MEMORANDUM

TO: Kaori Torigai, PM, YG

FROM: John Brodie, P. Eng.

SUBJECT: Intermediate Dam Rip Rap
DRAFT PENDING FURTHER FIELD ASSESSMENT

Intermediate Pond Water Elevations

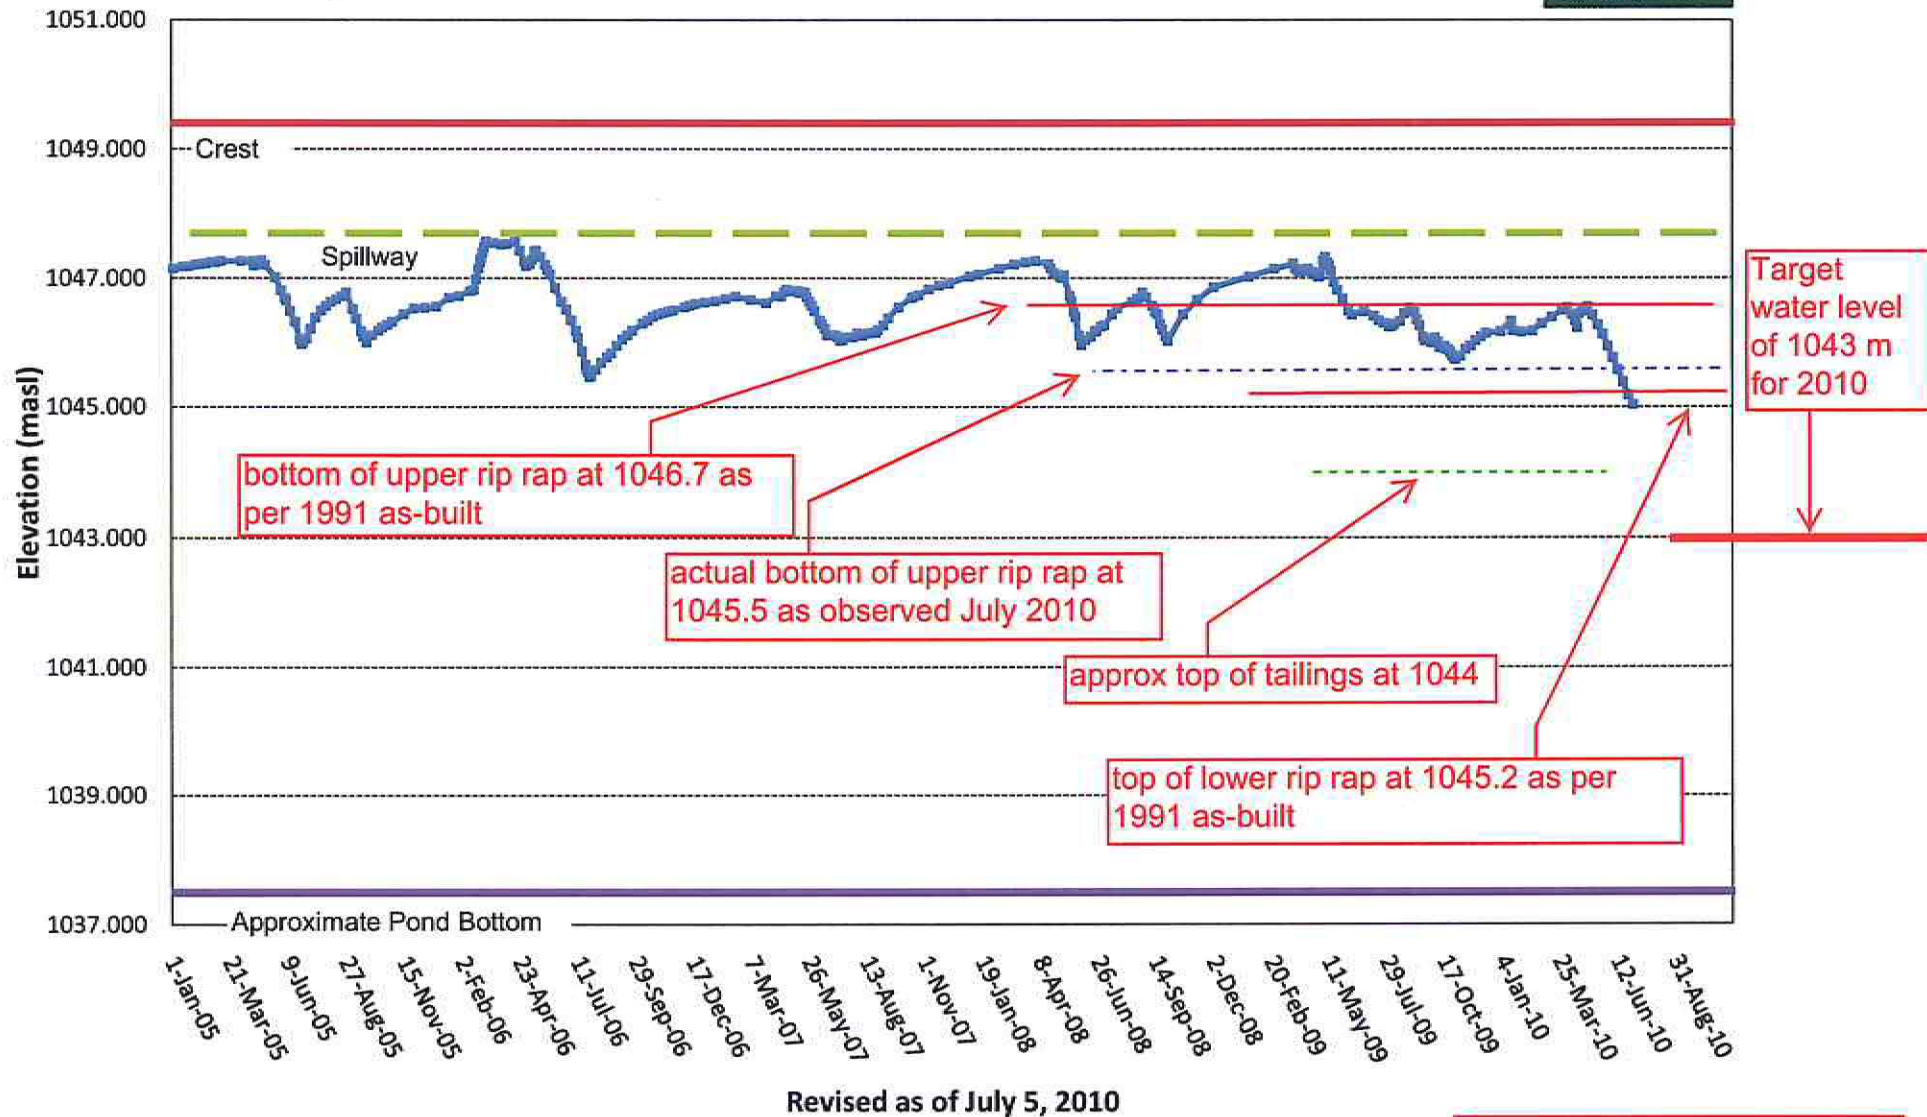
In order to reduce the risks associated with site water management, it has been decided that the Intermediate pond is to be operated at a level which is lower than historic levels. The current target is 1043 +/- m elevation. See Figure 1. We may be only able to approach but not meet this target in 2010 due to limits on the maximum drawdown rate to ensure stability of the upstream slope of the dam.

Figure 1, attached, shows the historic water level trends since 2005 with key elevations annotated. Figure 2 shows the Int. Dam in cross-section with similar annotation.

Figure 2
Int. Dam Rip Rap Assessment
BCL July 2010

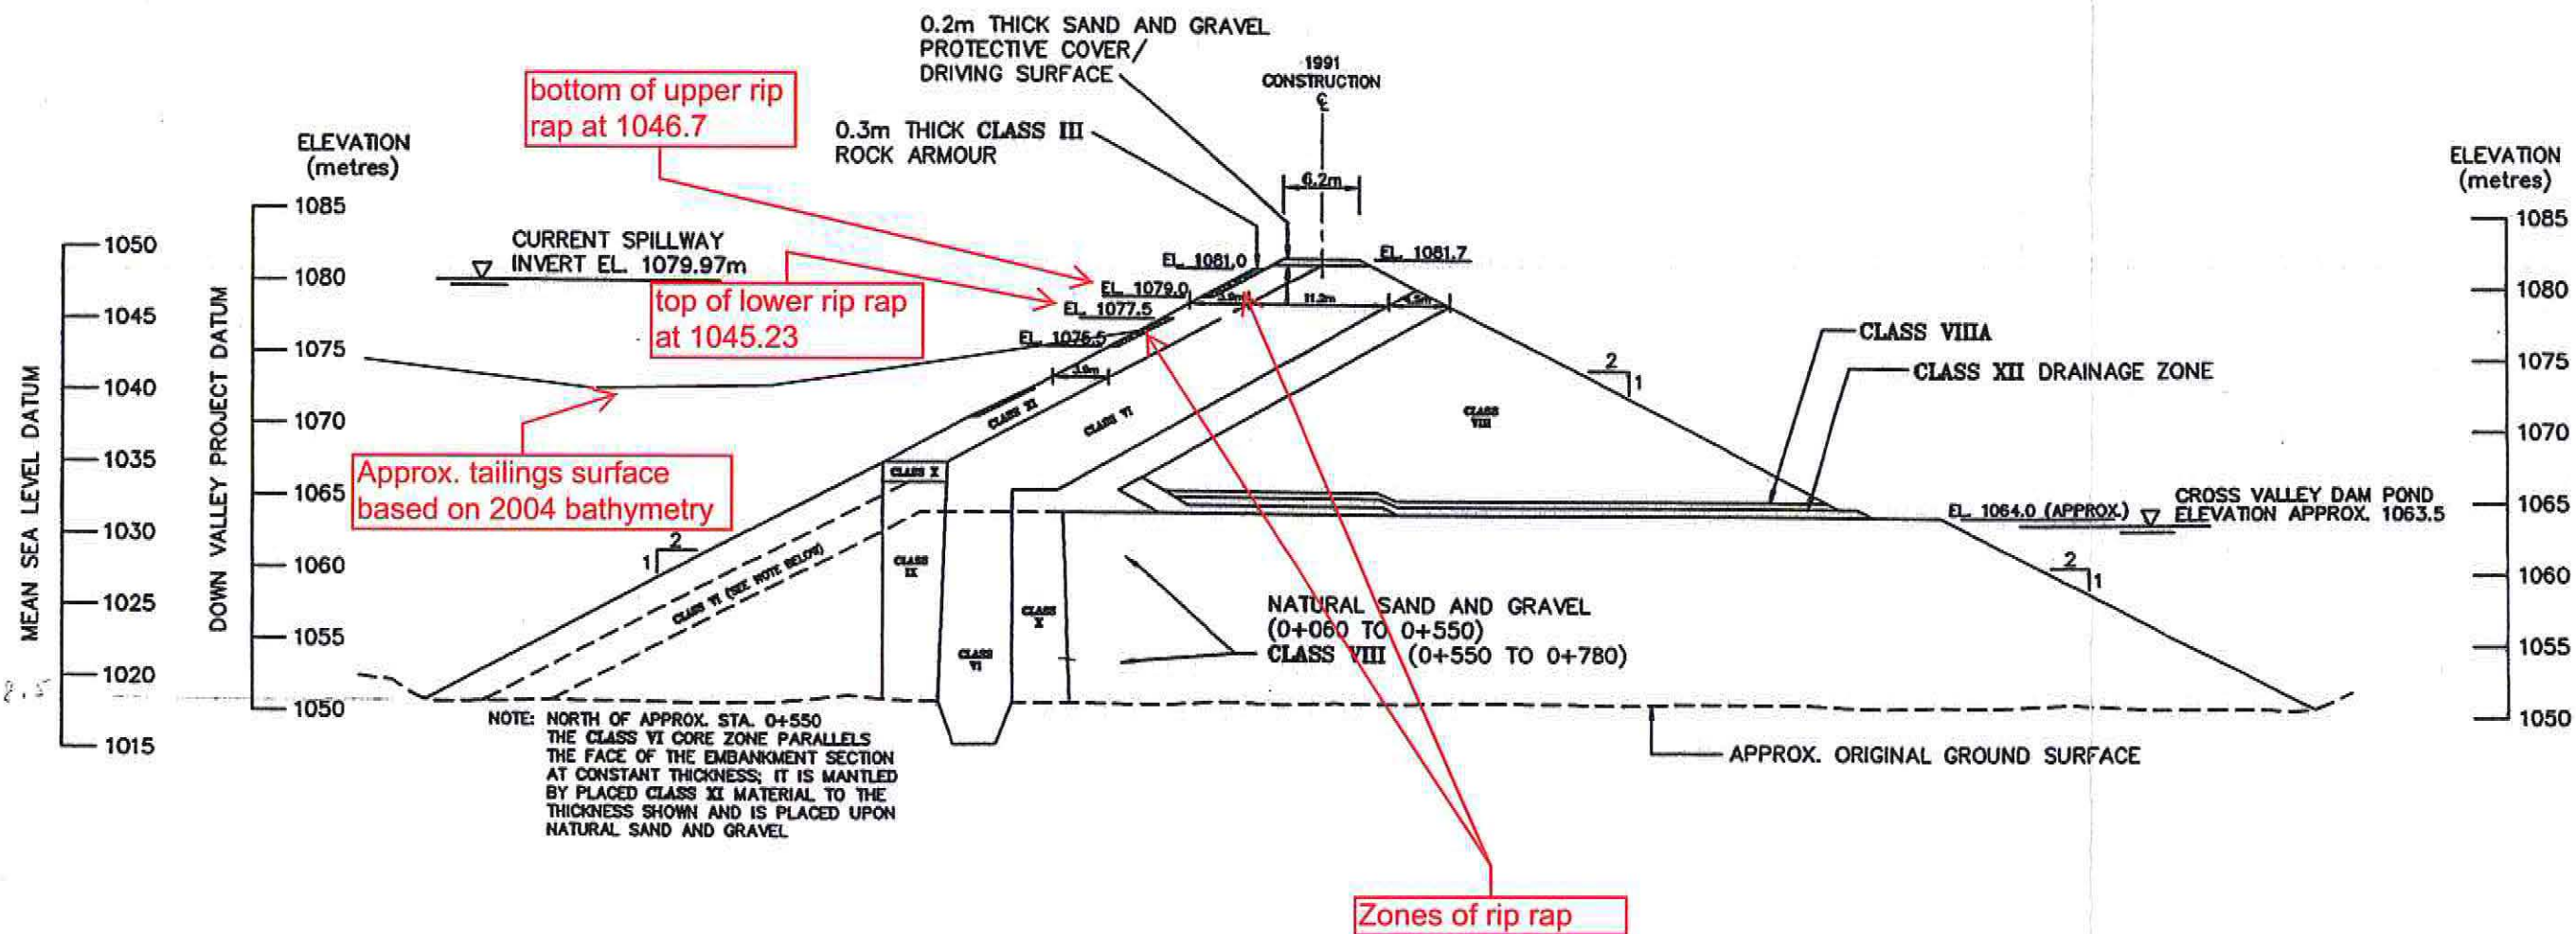
The historic lower limit for operation of the pond was based upon not exposing the interval on the up-stream face of the dam which does not have rip rap, and it was anticipated that lowering the pond water level in 2010 would expose this interval. The top of this interval has recently been found to be at 1045.5 +/- m elevation. This is different from what is indicated in the available records (see Figure 2). However, BGC 2009 Annual Geotechnical Evaluation and Instrumentation Review page 18 notes:

At this time we are unable to locate any as-built information concerning the location and scope of those repairs. The existing rip rap surface is very steep and loose, which suggests that the 2007 repair consisted of placing a layer of new rip rap over the dam face to blanket the interval without rip rap. This was done down to the limit which could be reached with the available equipment.

Option 1 seems like an excessive amount of work to address a small (0.5 m) gap in the rip rap at point which is well below the crest of the dam and would be a deficiency only until the closure plan is implemented. The extent of the gap in the rip rap must be confirmed. Assuming actual conditions/dimensions on the dam are found to be as described herein, then Option 1 seems less preferable than Option 2.

Option 2, by default appears to be the best option, although it should be noted that this is a departure from best management practice for a dam. It is only acceptable if:

- monitoring of the face of the dam is carried out as described, and,
- water level control is carried out to the extent practical, and,
- the situation is temporary (implementation of closure measures will be conducted), and,
- return to Option 1 is taken if monitoring indicates that the integrity of the dam is at risk.
